Docket Item # 22
BAR CASE # 2007-0234

BAR Meeting
November 14, 2007

ISSUE: Alterations to Previously Approved Plans

LOCATION: 1600 King Street

Figure 1: King St (North) Elevation of 1600 King St

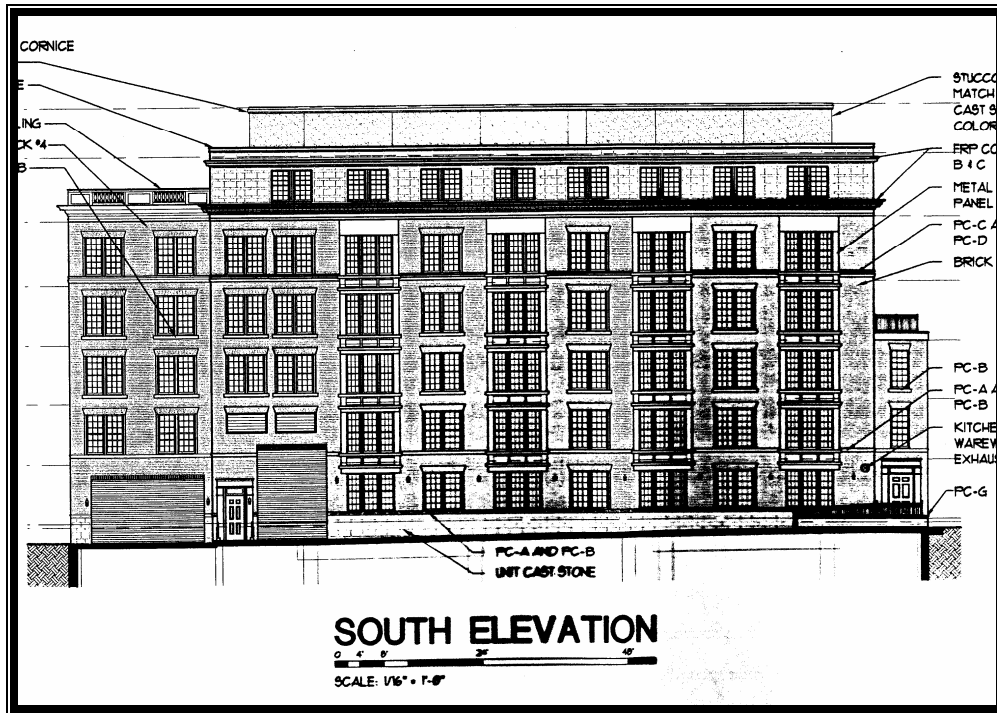
Staff initially had substantial concerns about the addition of a substantial rooftop element where there had previously been only two small structures. The currently proposed penthouse with screenwall is nearly as large as the sixth floor it rests on. However, Staff is convinced that the architects and mechanical engineers have worked to ensure that only the necessary mechanical equipment is located on the rooftop and that it is as well located and as low as possible to minimize visibility and footprint. In addition, the penthouse is designed to be both compatible with the building and to be a background element, with its rectangular footprint echoing that of the main block of the building and its true stucco (not EFIS) cladding and cornice a quieter version of the classical architectural treatment of the sixth floor. Lastly and most importantly, based on sightline drawings and computer sketch up models provided by the applicant, Staff believes the penthouse will only be minimally visible from some viewpoints and will not be a significant visual element of the building.

While Staff admits that the differences between the Architect Series and ProLine windows are relatively minor, Staff continues to believe that the Architect Series is preferable. It has more substantial and authentic profiles. These are best seen at the muntin, jamb and sill.

Staff believes the proposed treatment of this historic façade is appropriate, given a lack of information about the original appearance, and a significant improvement over the mid- to late-20th century treatment that existed prior to the demolition. Originally, the applicant had

proposed aluminum storefront windows and entryway. As now proposed, the windows and doors will be wood. The storefront windows will fit the existing, likely non-historic, openings while restoring a more historic feeling through the use of a transom and vertical divisions within the main window. Similarly, the entryway restores a historic feeling to what is likely a non-original opening.

1. That Staff review and approve the on-site materials mock up;
2. That the windows be the previously specified Pella Architects Series windows; and,
3. That the applicant comply with the archeological conditions listed the archeological comments below and in DSUP #2006-0036, 4/14/2007.

Figure 1: East Elevation of 1600 King St

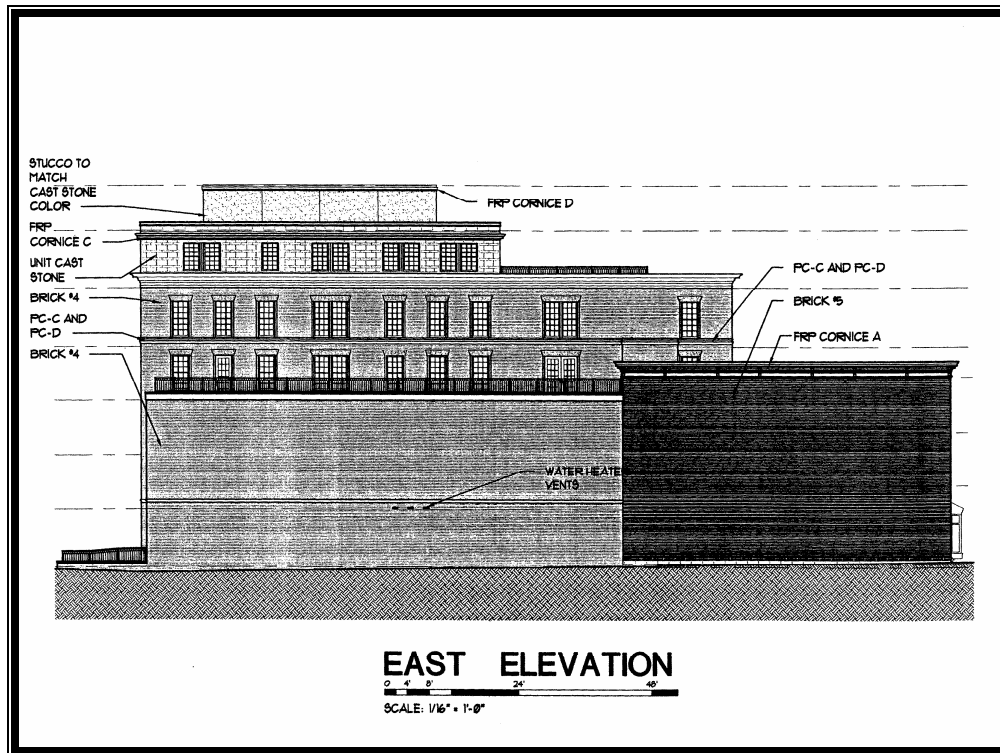
Staff has no objection to the proposed niche in the east wall of the western arm. Initially the niche caused some concern as it appeared as a strange aberration in the otherwise flush wall. However, at the request of Staff, the applicant changed the material lining the niche from EIFIS to brick and finished the opening with the brick jack arch and steel gate, giving it some architectural presence and integrating it into the vocabulary of the project. Staff notes that this area will not be highly visible as it is removed from the street face by approximately 7' and is on a passageway that is not anticipated to be highly trafficked.
